UNITED STATES PATENT AND TRADEMARK OFFICE

Office Action Summary	Application No.	Applicant(s)	
	10/581,266	OZAWA ET AL.	
	Examiner	Art Unit	
	OREN GINSBERG	3764

DETAILED ACTION

Figure 1: Visual demonstration of how the Halsted apparatus causes the user's own weight to act on their legs when the saddle oscillates up and down.

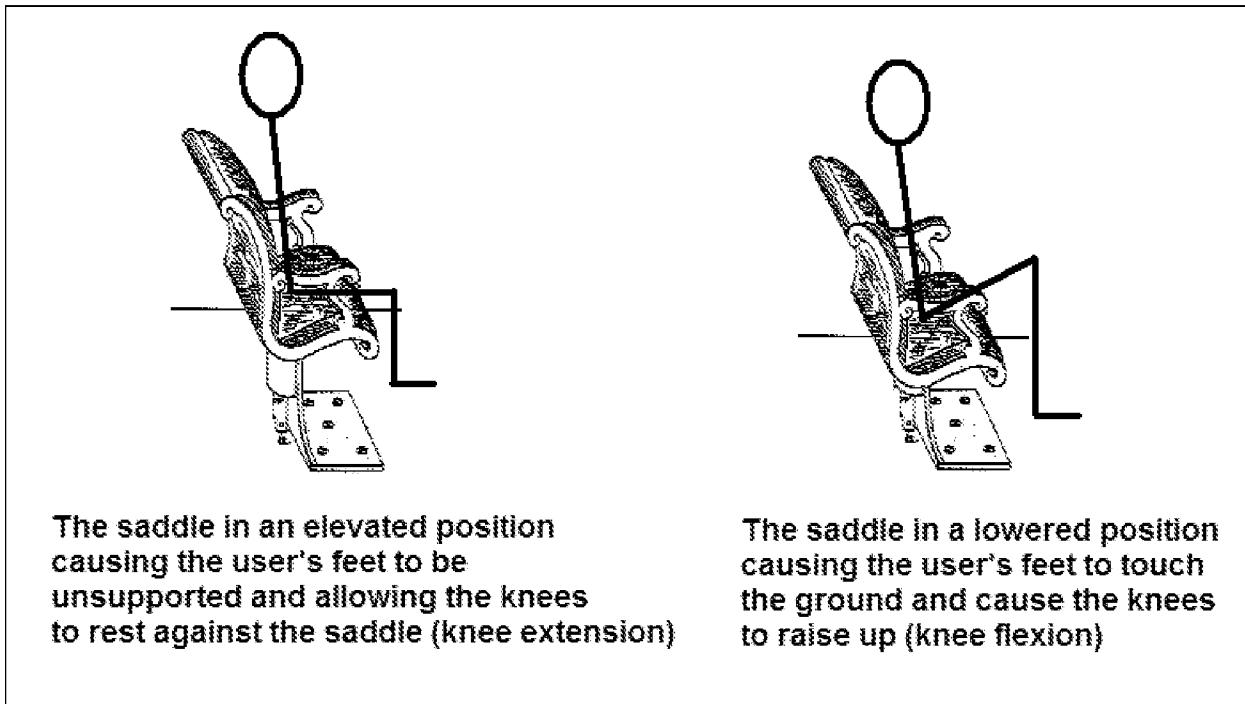
Halsted teaches a chair that moves up and down and oscillates between two points; a lowered and an elevated point. Halsted further teaches the chair only moves in a direction such that the load on the user's leg varies and positional displacement of the knee between flexion and extension of the joint. See figure 1 below for visual demonstration how this is the case.

When the saddle is in an elevated position, the knee is experiencing an increased load from gravity acting on the lower leg (calf, ankle, etc.). When the chair is lowered and the user's feet are resting on the ground, this takes the pressure off the user's knee experienced from the weight of the lower leg.
